Invitation for Bid No. 2024-030

Twelve Mile Creek WRF 9.0 mgd Expansion

ADDENDUM No. 1 **ISSUE DATE: July 25, 2024**

ADDENDUM NO. 1 TO CONTRACT DOCUMENTS

DATE:	JUNE 2024
HAZEN NO.:	30831-061
CONTRACT NO.:	1
DRAWING NUMBER:	M112

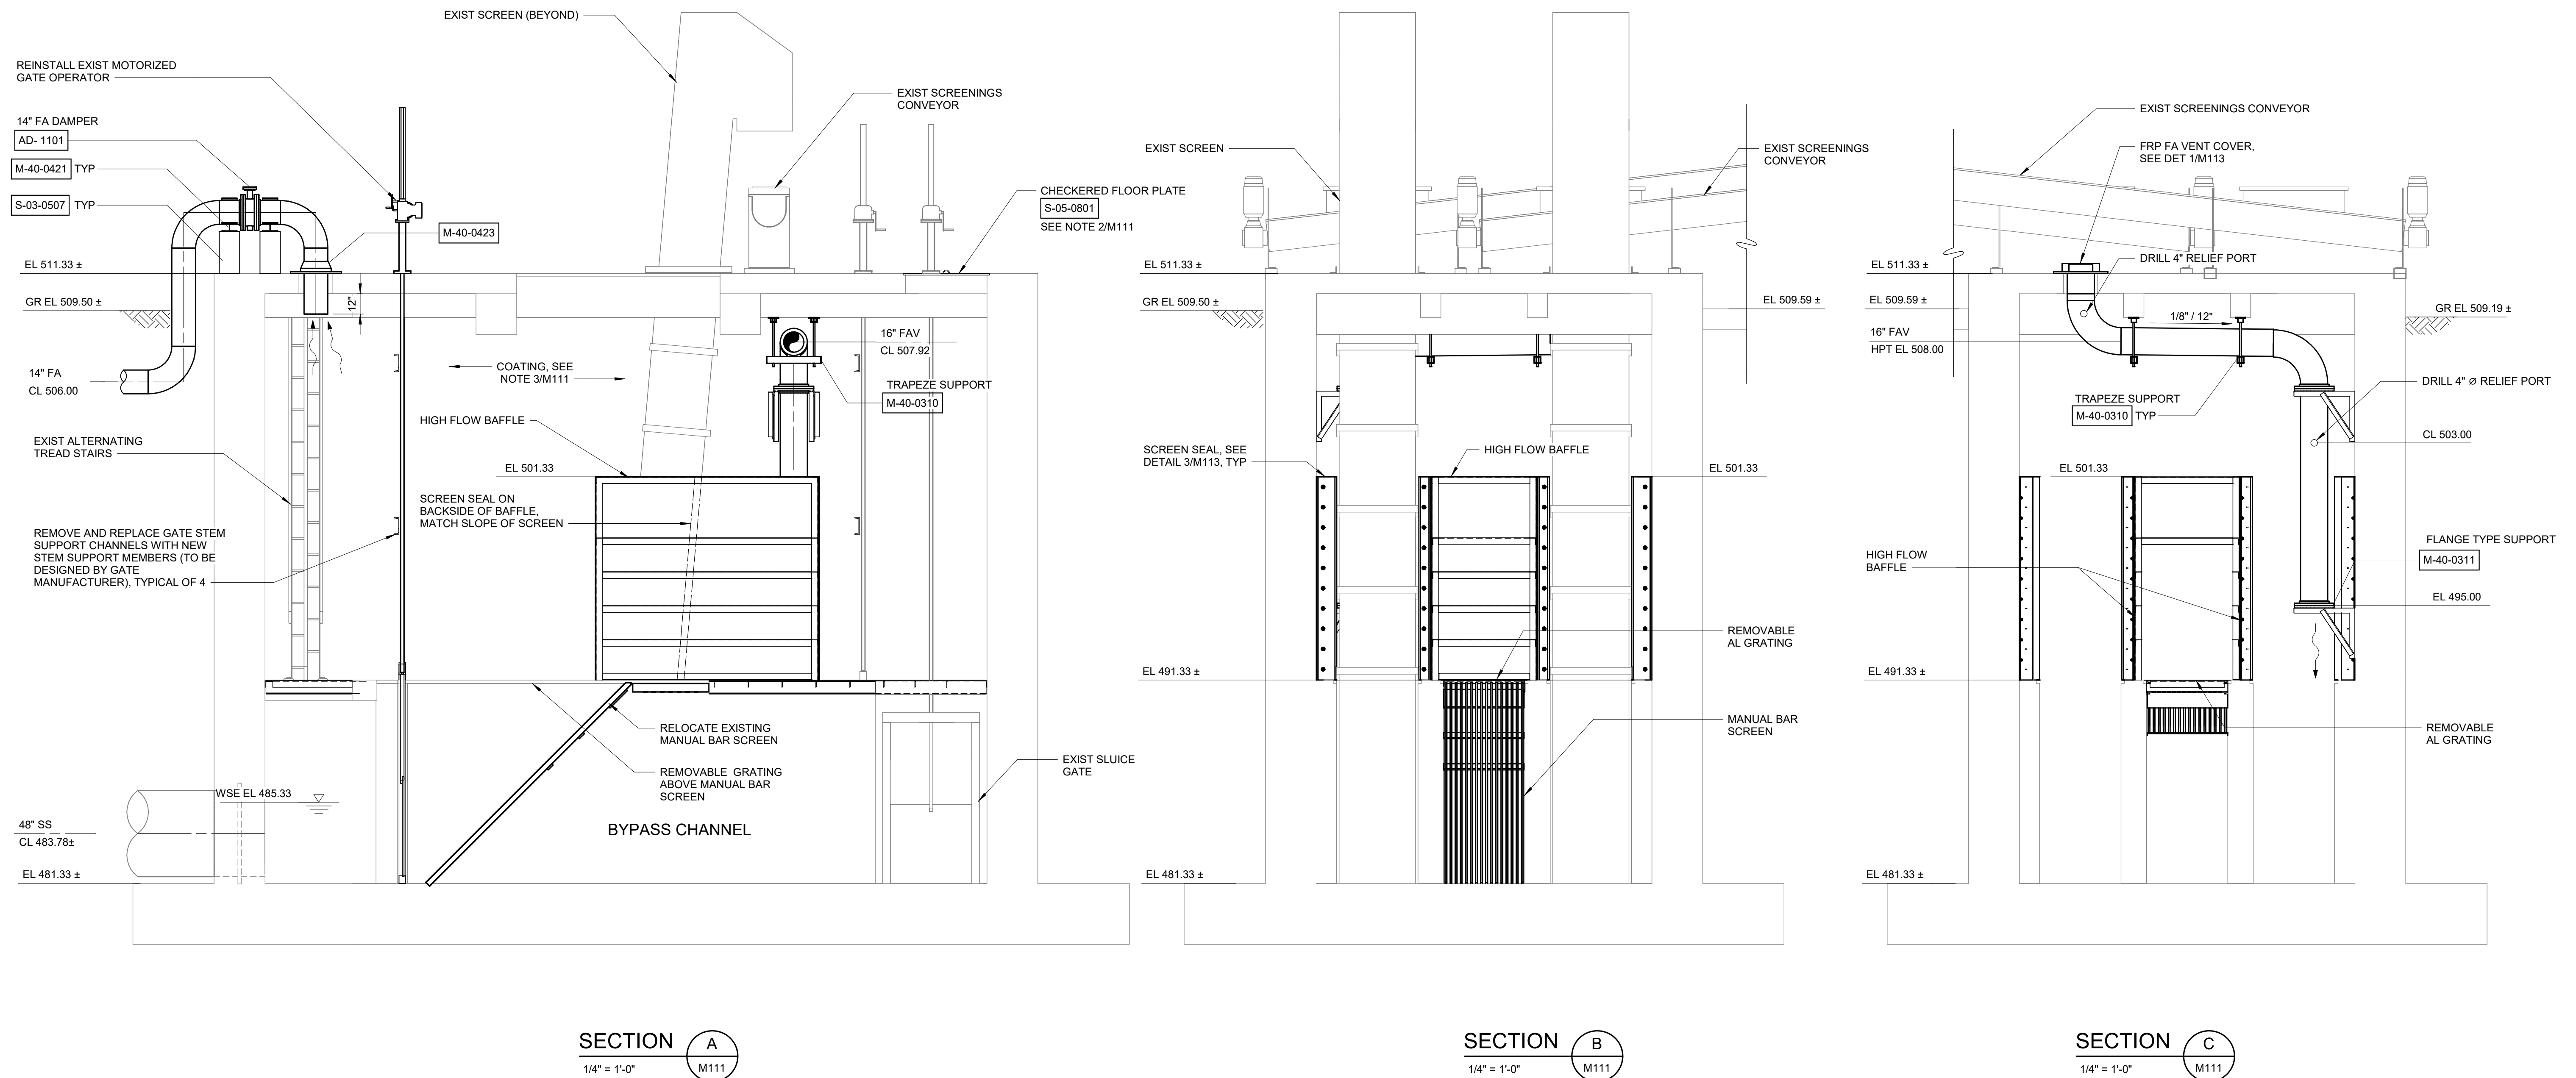
DRAWINGS M110 – M114

Replace drawings with the attached drawings.
